# Appendix: Previously Reviewed Baseline Upgrade Recommendations for the September 2021 PJM Board Review

# Changes for Existing Projects

## Baseline Reliability Projects

## Replace B3278.1 (Presented in 12/18/2020 and 2/17/2021 SR RTEP) With B3278.3

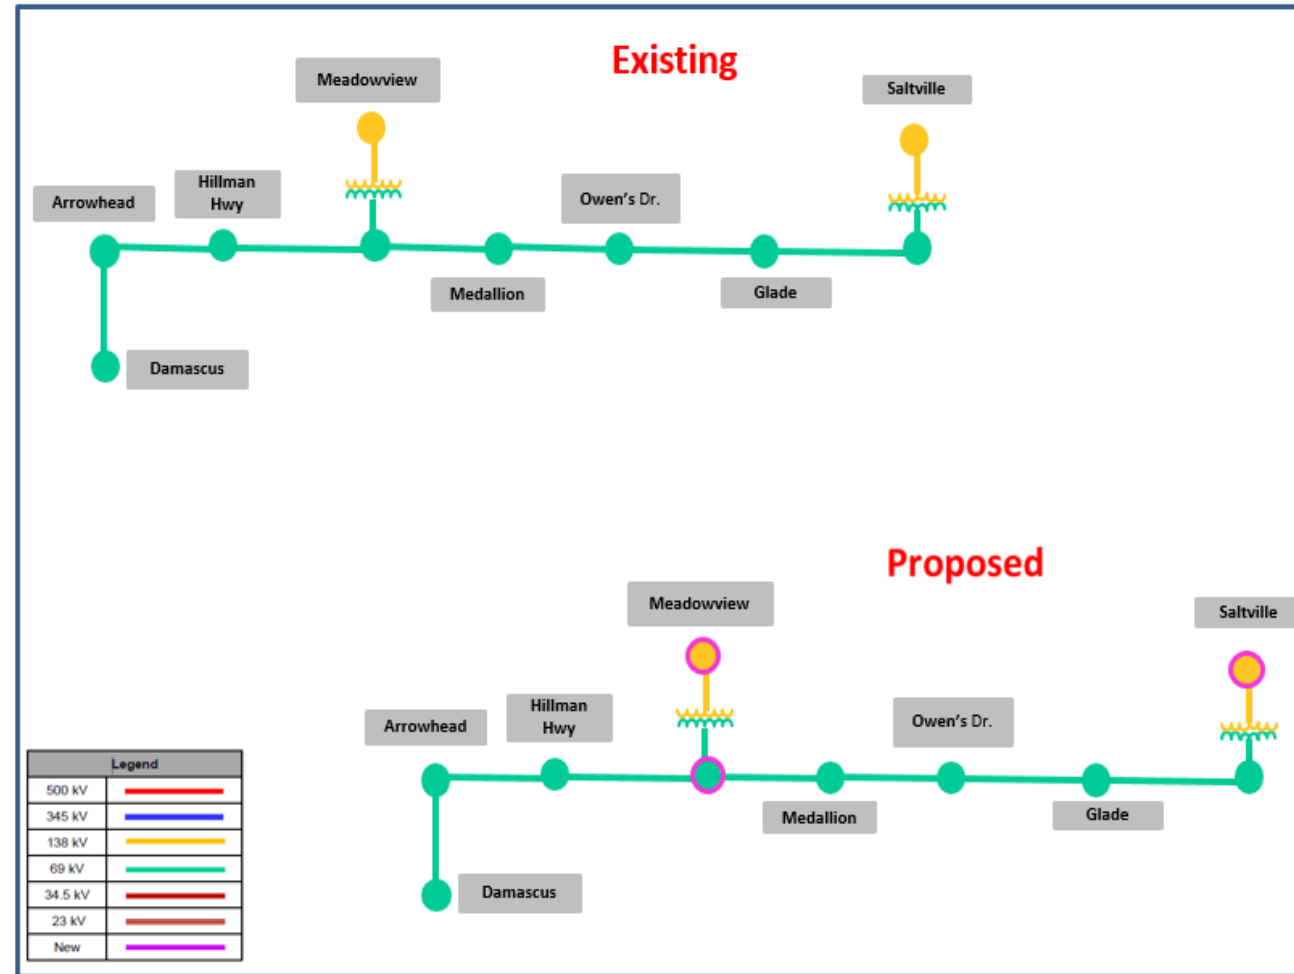
**B3278.1:** Saltville Station: Replace H.S. MOAB Switches on the high side of the 138/69-34.5 kV T1 with a H.S. Circuit Switcher.

**B3278.3:** Saltville Station: Install two breakers and bus diff protection.

**Reason for the scope change:** AEP-2020-AP037 and AEP-2021-AP004 solution, that requires reconfiguring Saltville station into a breaker-and-a-half arrangement, would eliminate the need for the switcher. By replacing the switcher with just the cost of the breakers that now protect the transformer, the same result is achieved.

**NOTE:** If the supplemental project is cancelled, B3278.3 will be cancelled and B3278.1 will be re-activated.

# JCPL Transmission Zone Baseline upgrade B2586 Cancellation

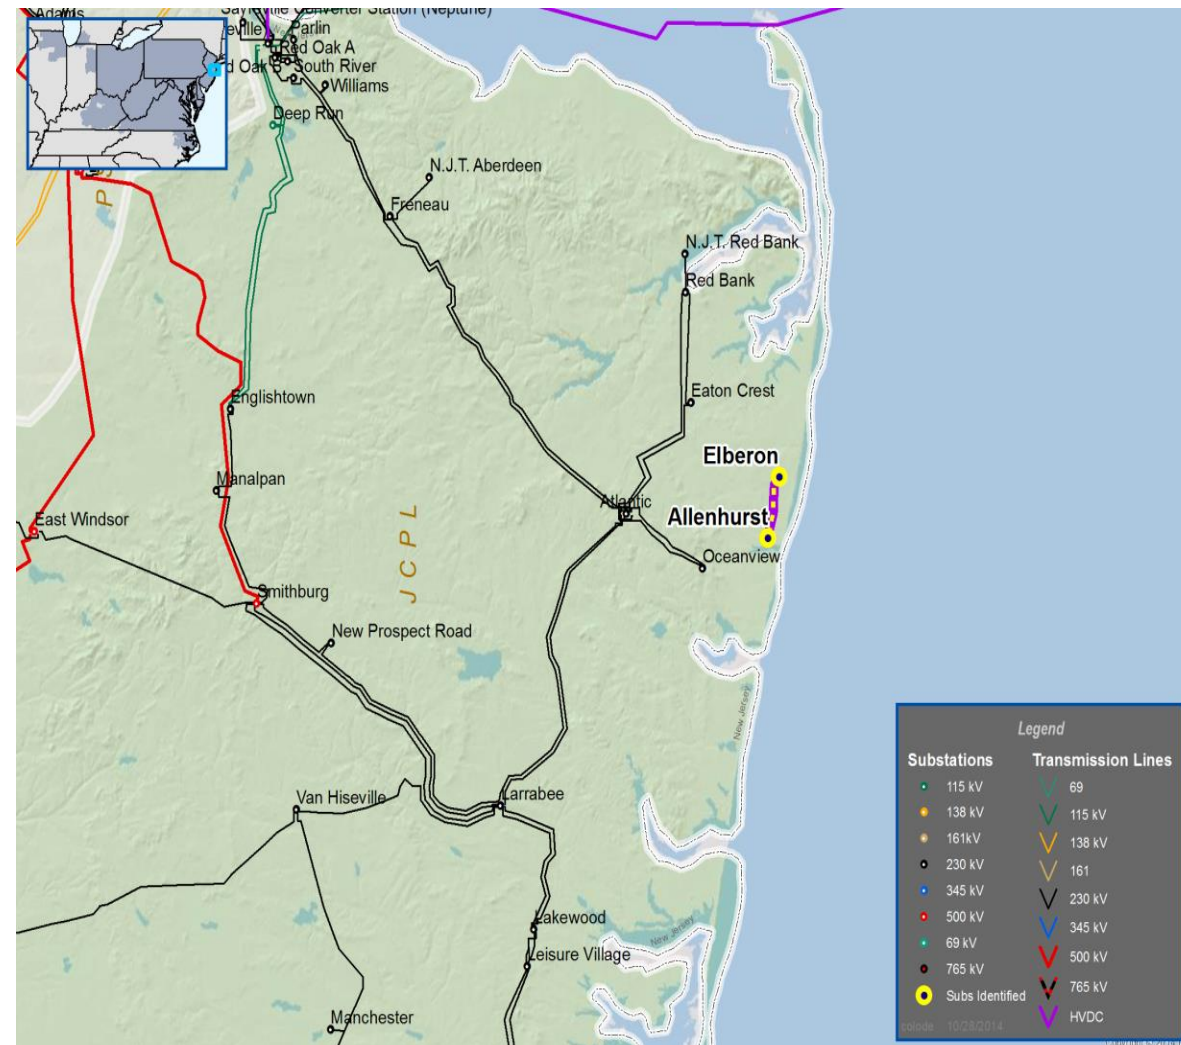
- The Allenhurst to Elberon (V74) 34.5 kV circuit is overloaded for the loss of the Bath Avenue – Long Branch (V74) 34.5 kV circuit.
- The Bath Avenue – Long Branch (V74) 34.5 kV circuit is overloaded for the loss of the Allenhurst to Elberon (V74) 34.5 kV circuit.

- Upgrade the V74 34.5 kV transmission line between Allenhurst and Elberon Substations. (2014\_2-4F)

The Allenhurst to Elberon 34.5 kV circuit will be upgraded as part of the MCRP project.

- B3130.9 Rebuild/Reconductor the Allenhurst to Elberon (2.0 Miles) 34.5 kV circuit
- The B2586 will be replaced with B3130.9 and will be canceled.
